Comments By: John Lehning		Resolved By: Tim Sande
#	Comments	Resolution
1	<p>The NRC staff cannot determine whether Alion’s proposed matrix of additional tests will be adequate to justify the intended result of 10% erosion prior to the performance of the tests and review of the resultant data. While the staff concluded, based in part on the number of samples to be used and increased test procedure controls, that it is possible that the planned additional testing will provide sufficiently consistent and coherent data to justify the intended result, clearly the outcome of the additional tests cannot be predicted. The staff further stated that it was appropriate to consider both the results from the planned additional testing, as well as the existing test data, as applicable, in determining a 30-day cumulative erosion percentage.</p>	<p>Alion acknowledges that there may be unexpected results from the testing. However, as long as the test results match the erosion theory described in the methodology report, the planned test matrix will provide adequate justification for a specific erosion fraction. Based on our experience, Alion believes that 10% erosion is an appropriate value. Howeve

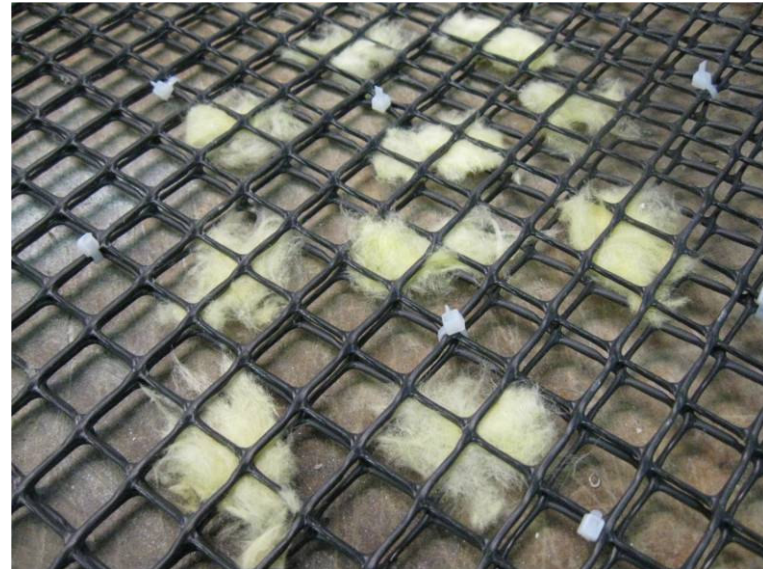
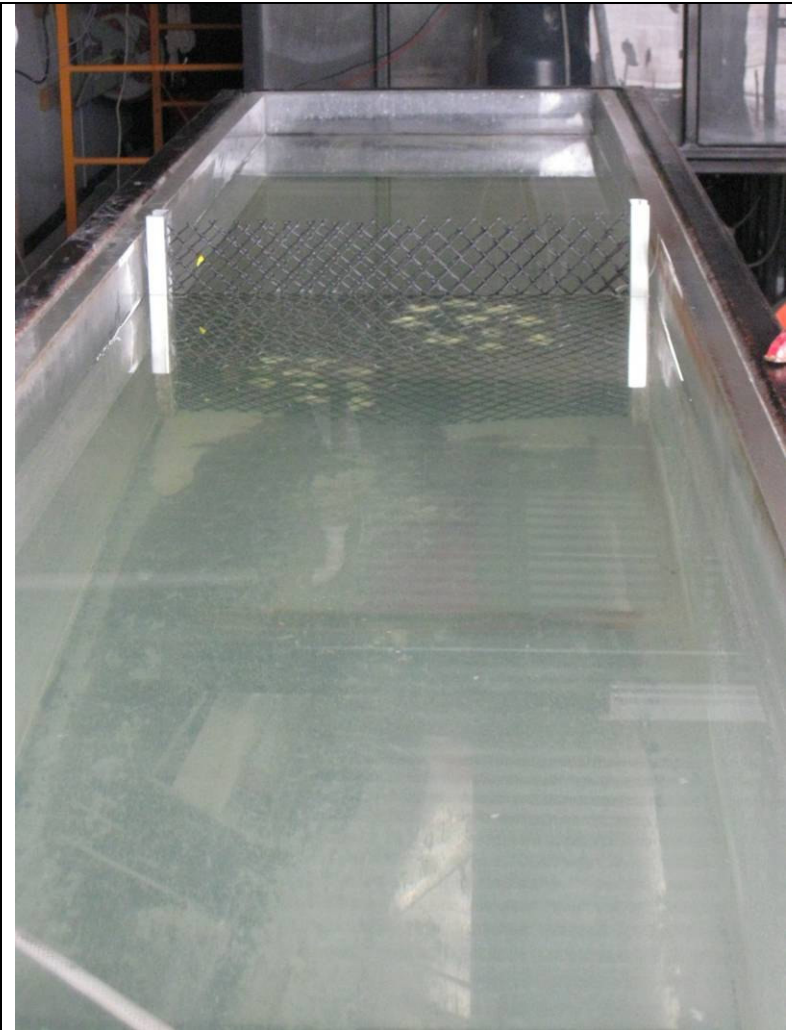
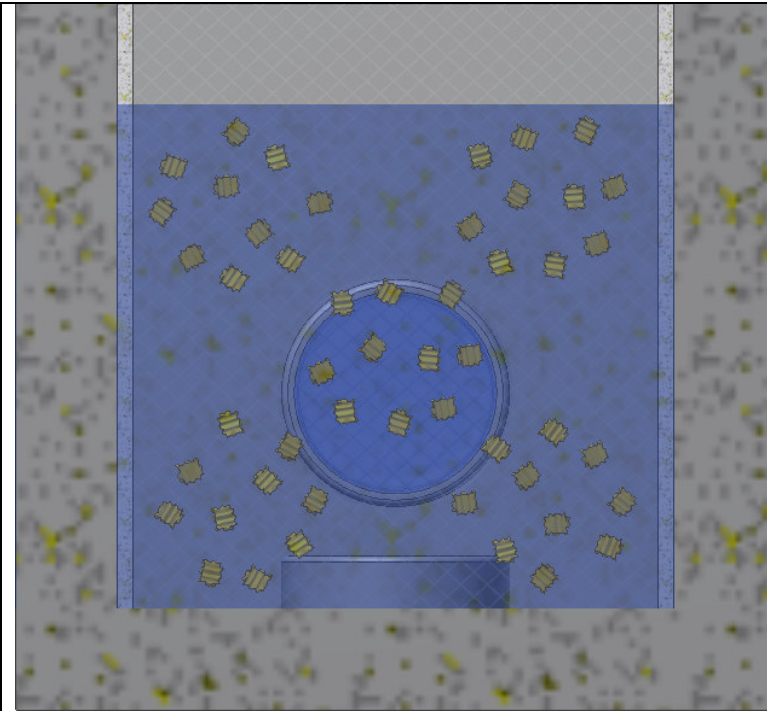
4	<p>The staff stated that it would be important to ensure that the debris pieces used for the erosion testing are exposed to representative flow conditions (e.g., velocity and turbulence). After reviewing results from Alion's computational fluid dynamics model of the</p>	<p>There will always be some flow variations in the flume. Alion has modeled some potential modifications to the flume with the intent of more evenly distributing the flow across the samples as well as generating enough turbulence to bound the plant</p>

erosion test flume configuration for the existing erosion testing, the staff was concerned that the lack of a fully developed velocity profile and low flume turbulence relative to plant containment pools could also be an issue for the proposed testing. In addition, the staff was concerned that Alion's placement of several sample racks in series in the test flume could further result in a "shadowing effect," by which upstream samples and sample racks would reduce the velocity and dampen the turbulence to which downstream samples would be exposed. Alion stated that the addition of a pre-filter to the test flume would help to reduce the velocity stratification apparent in the computational fluid dynamics results for the existing testing. Alion also stated that additional computational fluid dynamics modeling of the flume configuration for the planned testing was being performed to verify aspects of the turbulence modeling and demonstrate representative flow conditions for the planned testing. The staff suggested that Alion discuss the velocity and turbulence results from the additional computational fluid dynamics modeling with the staff prior to performing the planned erosion testing. The staff further suggested that Alion align the test debris pieces in a manner that would minimize the velocity and/or turbulence defect resulting from upstream samples "shadowing" downstream samples.

specific conditions. The CFD analysis and recommended test configuration is being provided in a separate PowerPoint file for NRC review.

The pictures below illustrate how the samples will be exposed to flow on the sample racks. Although the samples will obstruct the flow slightly, the gap between samples allows flow to easily pass through the sample group. Also, the sample racks will be spaced far enough apart at a distance that, based on the preliminary CFD results, is well past the "shadow effect" caused by the upstream samples.

The following pictures show the placement of two of the five sample groups.

As shown in the figure below, the five sample groups fill up most of the cross section of the flume, and changing the sample group orientation on the downstream sample racks would not significantly affect the flow.

ALION ACTION: Submit the final flume configuration, (with turbulence inducers) to the NRC .
